# SOUTHMOOR RETAIL PLAZA CONDITIONAL USE SITE PLAN COVER SHEET

COVER SHEET  
PROJECT RECORD NUMBER:  
DV-CUSP-20-00003  
DATE PREPARED: 10-16-2020  
PLANS PREPARED FOR:  
**TEBO DEV. CO**

# Summary of Comments on Layout1

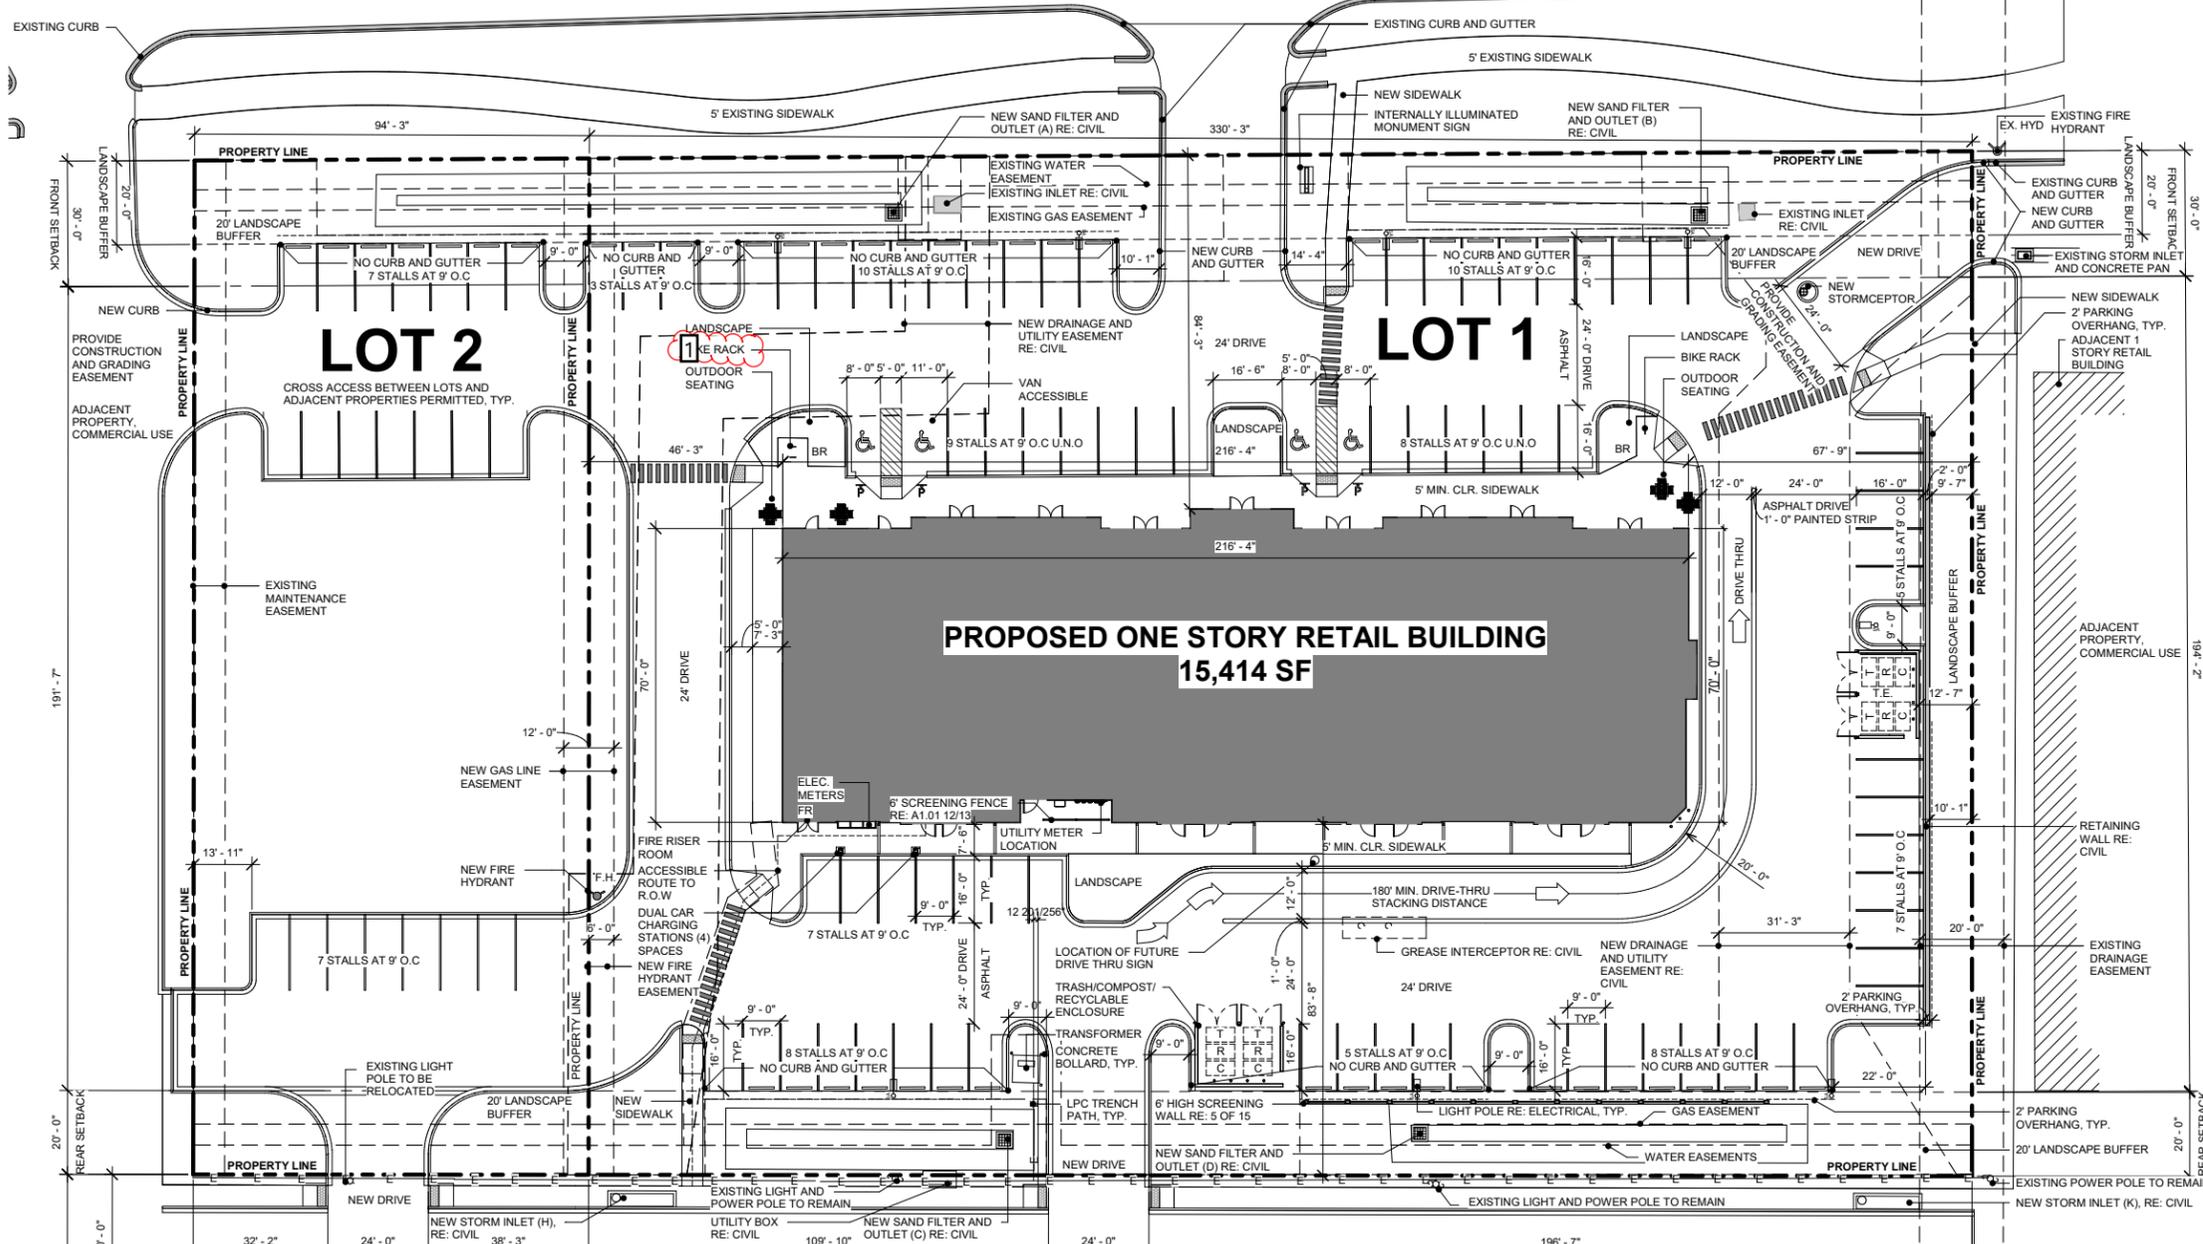
Address status of this existing water service line. The utility plan indicates a new service line being installed and this existing service line is to be removed? Please clarify.

SHEET  
3 OF 15

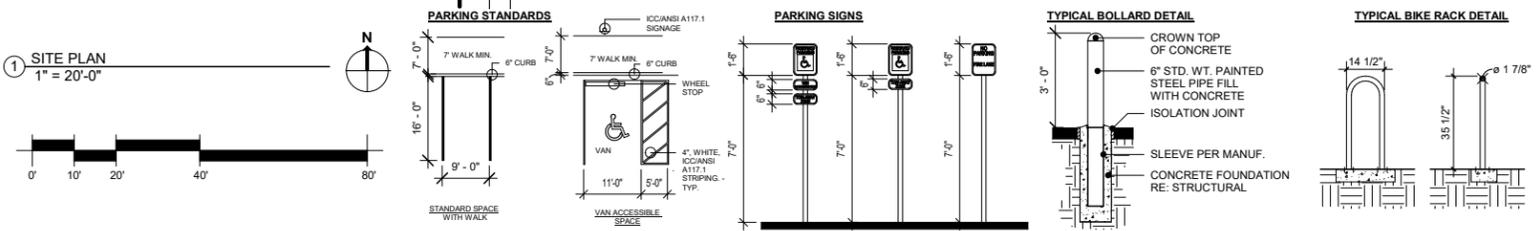
Number: 1 Author: PECHERZEWSKIAM Subject: Polygon Date: 12/10/2020 9:00:50 PM  
Re-Label as "2 Bike Racks" to better clarify for the contractor that 2 bike racks are expected at this location. This is consistent with the bike rack amounts depicted in the Landscape Plan.

Number: 2 Author: NELSONEL Subject: Sticky Note Date: 12/4/2020 9:09:43 PM  
On the plan label all sand filters per other plans (i.e. add A, B, etc).

Number: 3 Author: NELSONEL Subject: Sticky Note Date: 12/4/2020 9:14:04 PM  
On the site plan show and label area inlets.

## GRADING AND DRAINAGE PLAN

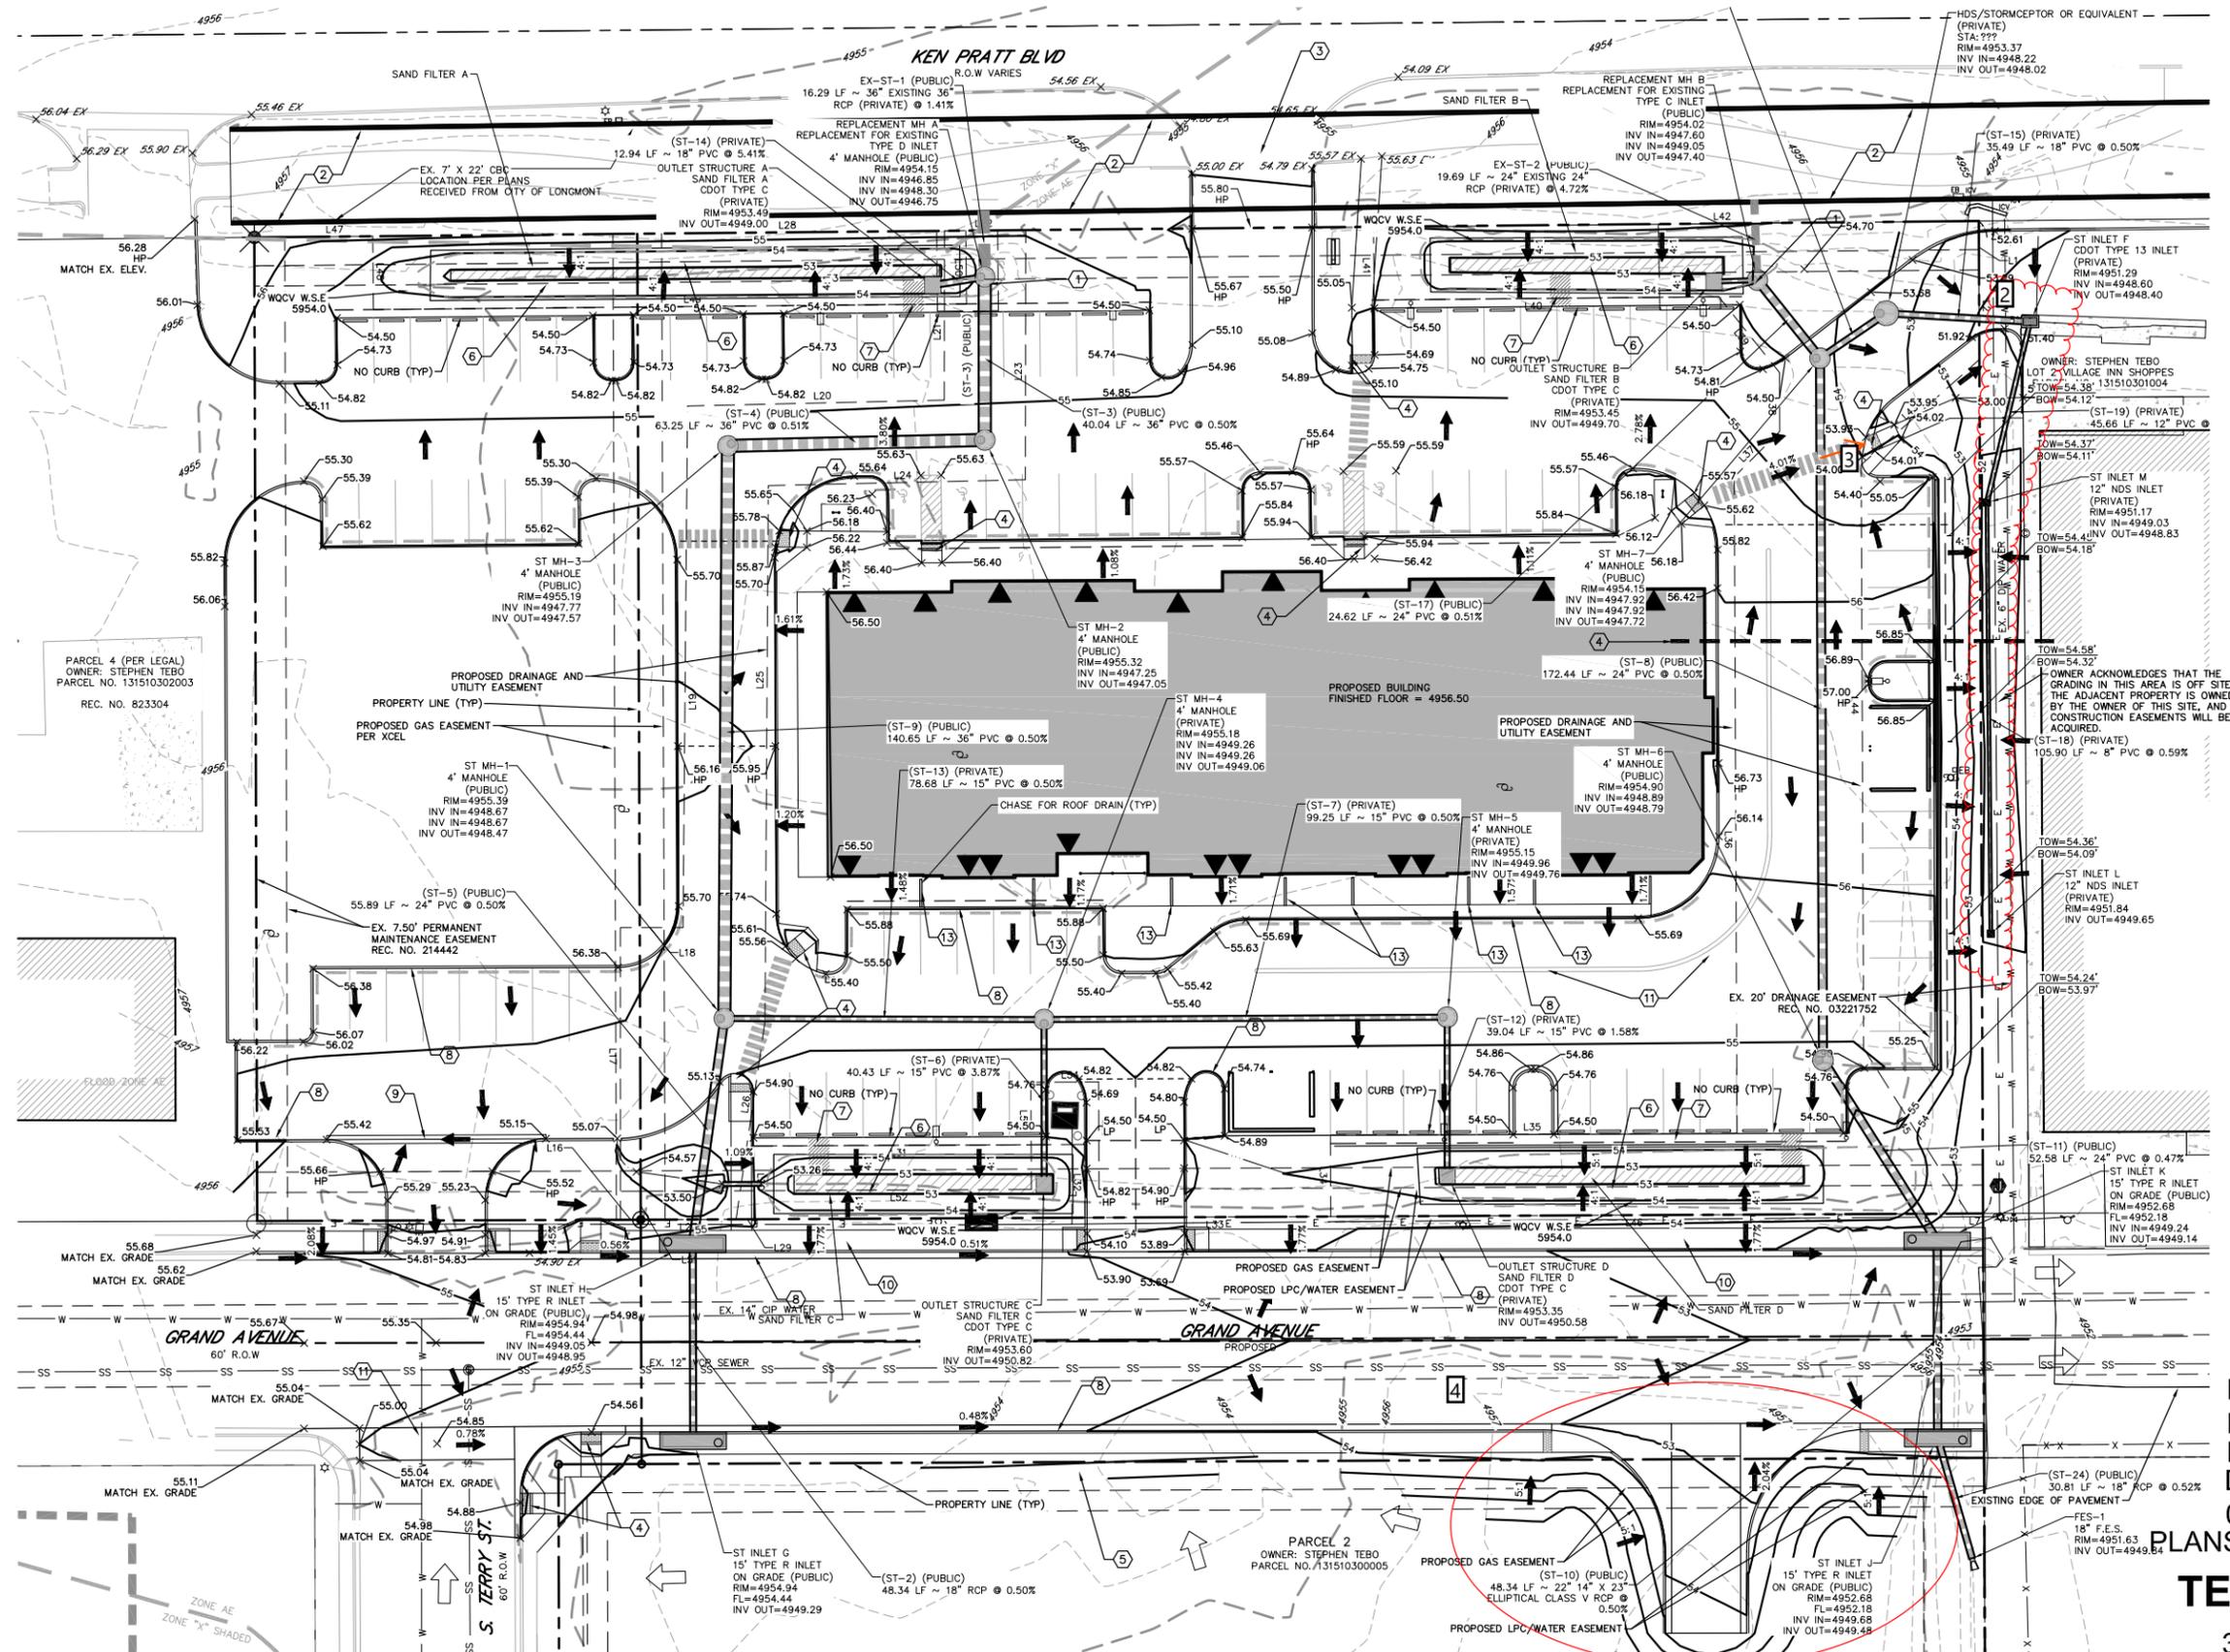
Number: 1 Author: NELSONEL Subject: Sticky Note Date: 12/4/2020 9:15:23 PM  
Attach updated sheet per comments made for the same sheet included in master drainage report and final site drainage report.

Number: 2 Author: NELSONMC Subject: Polygon Date: 12/7/2020 4:25:37 PM  
Add drainage easement for proposed infrastructure. Add maintenance responsibilities in maintenance notes.

Number: 3 Author: Kevin Subject: Line Date: 11/27/2020 10:09:24 AM  
Repeat comment: provide high point so that stormwater is not being directed down the ped walk.  
2/100 of an inch is less than standard construction tolerance for flatwork, not sufficient.

Number: 4 Author: NELSONMC Subject: Oval Date: 12/7/2020 4:27:43 PM  
Effects on CLMR to be determined with the PIPs.

## UTILITY PLAN

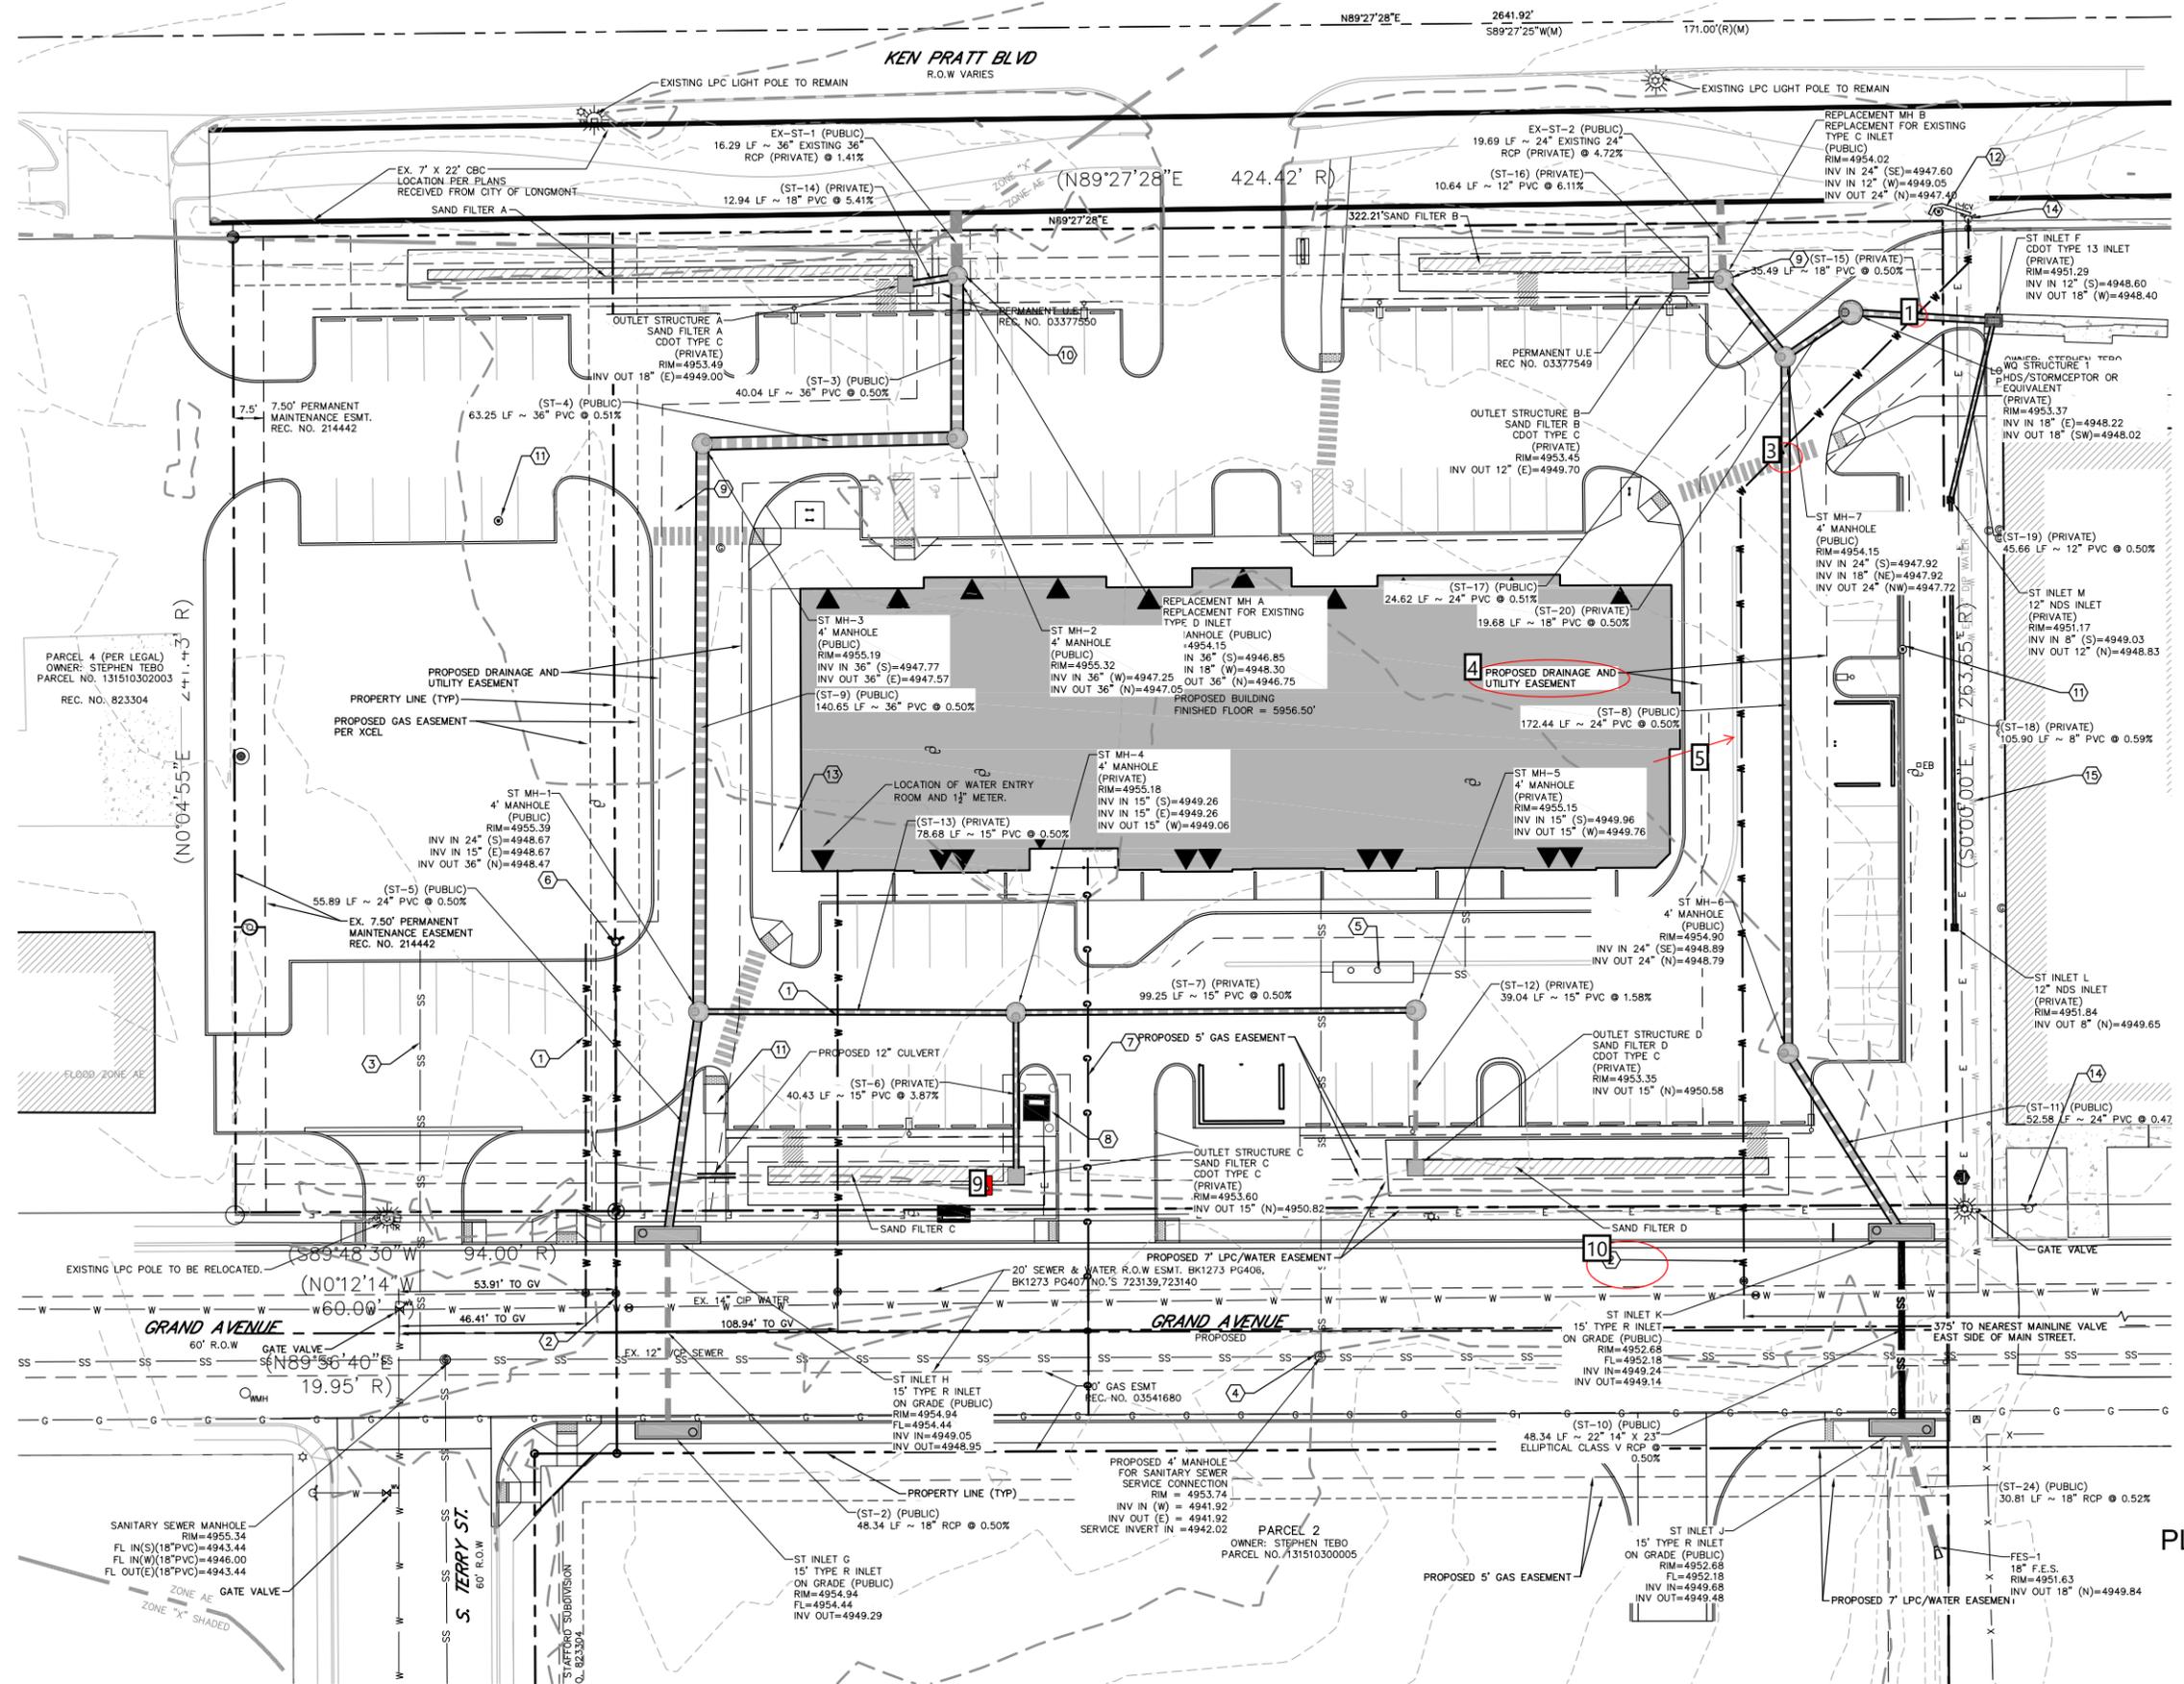
- 
-  Number: 1 Author: NELSONMC Subject: Oval Date: 12/8/2020 9:34:23 AM  
Add profile for this crossing. minimum 1.5 vertical clearance required.

-  Number: 3 Author: NELSONMC Subject: Oval Date: 12/8/2020 9:33:50 AM  
Add profile for this crossing. minimum 1.5 vertical clearance required.

-  Number: 4 Author: NELSONMC Subject: Oval Date: 12/8/2020 9:33:50 AM  
Include the hydrant service line in its own 20-foot easement. Public and private utilities should not share an easement.

-  Number: 5 Author: NELSONMC Subject: Line Date: 12/8/2020 9:33:50 AM  
Label the distance from the service line to the face of the building. 15 feet minimum separation required.

-  Number: 6 Author: NELSONMC Subject: Oval Date: 12/7/2020 5:17:45 PM  
Address in the demolitions sheet.

-  Number: 7 Author: NELSONEL Subject: Line Date: 12/4/2020 9:19:18 PM  
Update note 4 & 6 per comments made for he same notes included on drainage and grading plan in drainage report.

-  Number: 8 Author: NELSONEL Subject: Sticky Note Date: 12/4/2020 9:19:18 PM  
Update storm sewer alignment, information as needed per comments made for drainage reports.

-  Number: 9 Author: HOODJ Subject: Sticky Note Date: 12/2/2020 1:31:28 PM  
To alleviate some confusions between the CUSP & PIP, we feel that it may be beneficial to remove LPC's design within the CUSP and only show it in the PIP. This should eliminate any conflicting details between the two documents.

-  Number: 10 Author: NELSONMC Subject: Oval Date: 12/8/2020 9:30:35 AM  
Provide a 20 foot easement for the relocated hydrant service line.
